Notification No.:	20081113	Revision: 1.0	Page: 1 of 2
Release Date:	Nov 13, 2008		
Notification Status:	☐ Advisory	☐ Mandatory	☒ Announcement
Classification:	☐ Firmware	☒ Hardware	☐ Policy/Procedure
Description:	UBA Frame Modification		
Hardware:	UBA all models		
Interface:	n/a	Check Sum:	n/a
Firmware Version(s):	n/a	CRC (seed = 0000):	n/a

Customer Notification

Figure 1

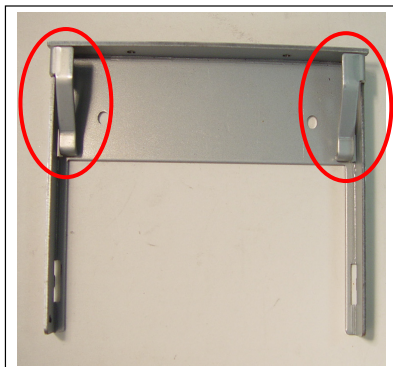
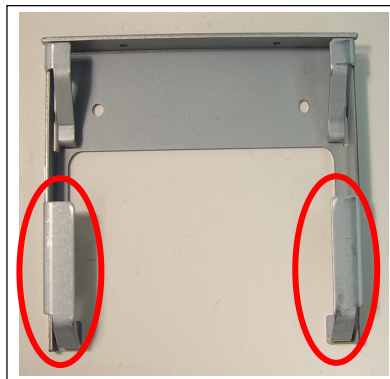
JCM Engineering has identified a condition where excessive forceful insertion of a cashbox into a UBA frame can cause damage to the TR stand.

JCM Engineering has developed a modification for the base of frames used in the UBA units. The original base plate has two supports at the rear (Refer to Figure 1). The frame modification has two added supports at the front of the base plate (Refer to Figure 2). This helps to support and properly align the cashbox when it is inserted into the frame. The new base plate is shown installed in the frame. (Refer to Figure 3).

Figure 4.

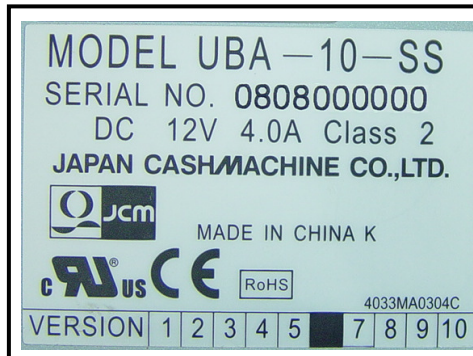
This modification will become standard on all production units beginning in August, 2008. (Serial numbers 0808XXXXXX) (Refer Fig. 4)
